PRODUCT ADVISORY

**Part Marking Configuration Change for
Intersil Product IS9-705RH*
(DSCC 5962R0053801*XC)**

**Refer to:
PA10040**

Marking examples:

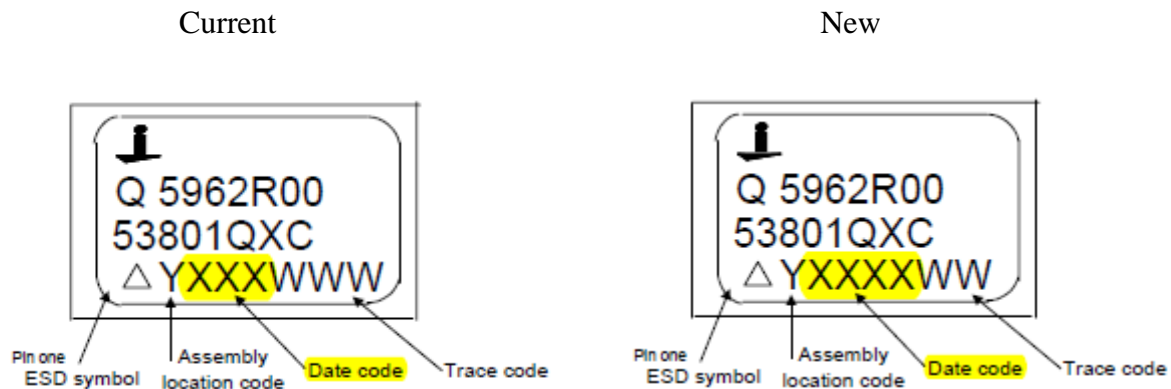
This advisory is to inform you that Intersil is changing the configuration of the “top side” marking (brand) for the listed IS9-705RH* (DSCC 5962R0053801*XC) products. The marking layout is being restructured to utilize a 4-digit date code (2-digit year plus 2-digit week) instead of the current 3-digit date code (1-digit year plus 2-digit week). The transition to the 4-digit date code format is necessary to eliminate confusion as to the year of product assembly (seal). This change will be implemented beginning with date code 1013.
